XC2700 Derivatives

16/32-Bit Single-Chip Microcontroller
with 32-Bit Performance

Errata Sheet

V1.7 2014-10

Figure 1 Critical application reset sequence

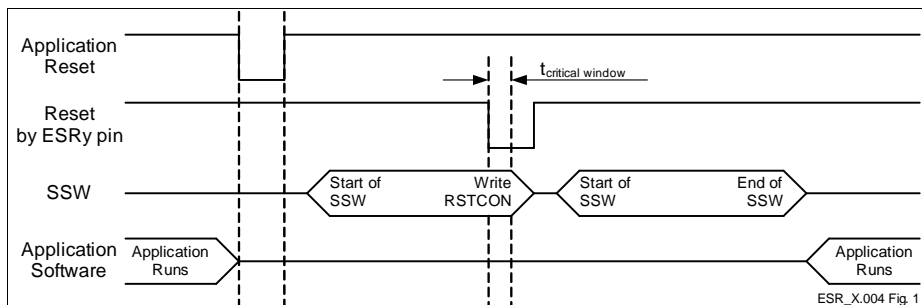
ESR X.004 Wrong Value of SCU_RSTCONx Registers after ESRy Application Reset

SCU_RSTCONx registers are reset only by Power-On, but they may be wrongly affected after a second application reset requested by an ESRy pin. This may lead to the SCU_RSTCONx register values being set to zero, which could unexpectedly disable reset sources within the user application. The conditions which lead to this behavior are:

1. First, an application reset by SW (software), CPU (Central Processing Unit), MP (Memory), WDT (Watchdog Timer) or ESRy (External Service Request y) occurs.
2. Following this, an application reset on an ESRy pin occurs.
3. If the above mentioned ESRy reset occurs during a critical time window of the SSW (startup software), then it's possible that the application will operate with the wrong SCU_RSTCONx register value. The critical time window occurs when the SSW is writing the SCU_RSTCONx registers, and at the same time, the ESRy reset request is processed by the reset circuitry. The width of this critical window $f_{critical\ window}$ is less than 13 cycles.

- Initialize `SCU_RSTCONx` registers by user software after any reset, or
- assure that a second application reset request with an ESR pin does not occur during the critical time window.

Figure 2 Example for Case 2: Interrupt Service for Task C delayed

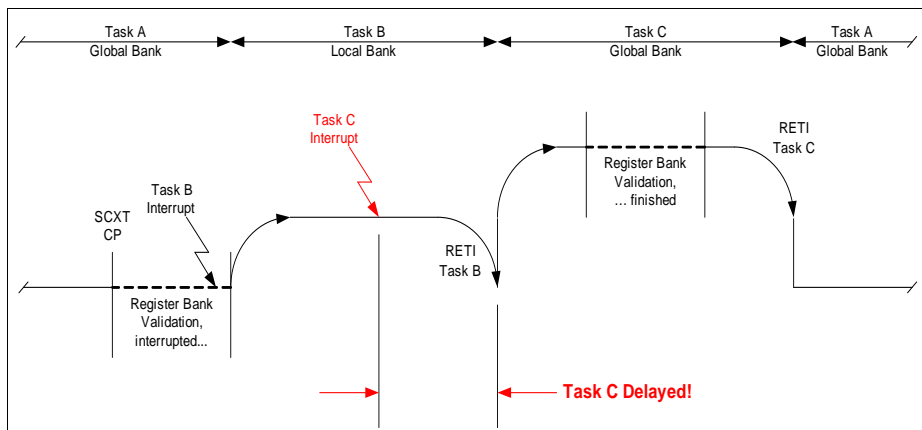
Case 2 (see also Figure 1):

- The Context Pointer CP is written to (e.g. by POP, MOV, SCXT ... instructions) within a routine (Task A) that uses a **global** register bank (bit field PSW.BANK = 00_B), i.e. the context for this routine will be modified,
- This context switch procedure (19 cycles) is interrupted by an interrupt request (Task B) which is programmed (with GPRSELx = 1X_B) to automatically use one of the **local** banks via the bank selection registers BNKSEL0...3 (i.e. the interrupting routine has a priority level ≥ 12),
- Before the corresponding interrupt service routine is finished, another interrupt request (Task C) occurs which is programmed (with GPRSELx = 00_B) to automatically use the **global** bank via the bank selection registers BNKSEL0...3 (i.e. the interrupting routine has a priority level ≥ 13).

In this case service of this interrupt request (for Task C) is delayed until bit field PSW.BANK becomes 00_B after executing the RETI instruction at the end of the routine (Task B) using the local bank.

Workaround for Case 2

When using both local and global register banks via the bank selection registers BNKSEL0...3 for interrupts on levels ≥ 12 , ensure that there is no interrupt using a global register bank that has a higher priority than an interrupt using a local register bank.

Figure 5 Alert Interrupt Behavior in case of Bus-Off

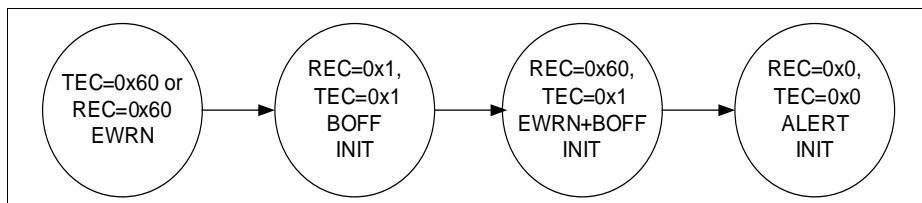
MultiCAN AI.H007 Alert Interrupt Behavior in case of Bus-Off

The MultiCAN module shows the following behavior in case of a bus-off status:

When the threshold for error warning (EWRN) is reached (default value of Error Warning Level EWRN = 0x60), then the EWRN interrupt is issued. The bus-off (BOFF) status is reached if TEC > 255 according to CAN specification, changing the MultiCAN module with REC and TEC to the same value 0x1, setting the INIT bit to 1_B, and issuing the BOFF interrupt. The bus-off recovery phase starts automatically. Every time an idle time is seen, REC is incremented. If REC = 0x60, a combined status EWRN+BOFF is reached. The corresponding interrupt can also be seen as a pre-warning interrupt, that the bus-off recovery phase will be finished soon. When the bus-off recovery phase has finished (128 times idle time have been seen on the bus), EWRN and BOFF are cleared, the ALERT interrupt bit is set and the INIT bit is still set.

Figure 6 Loss of Arbitration

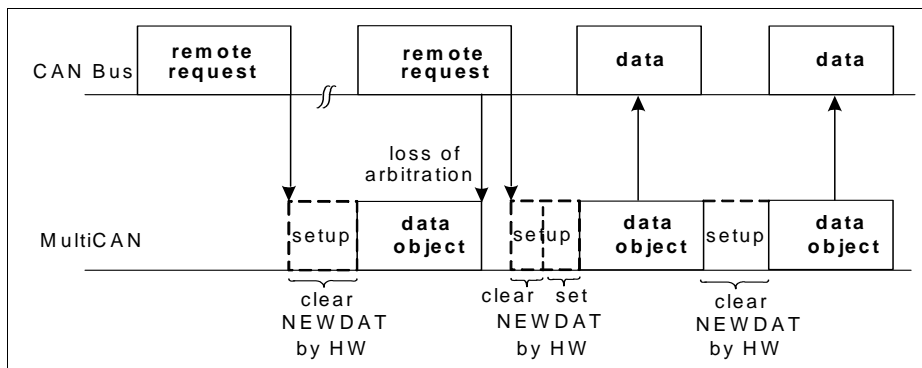
When the appropriate message object (data frame) triggered by the first remote frame wins the arbitration, it will be sent out and NEWDAT is not reset. This leads to an additional data frame, that will be sent by this message object (clearing NEWDAT).

There will, however, not be more data frames than there are corresponding remote requests.
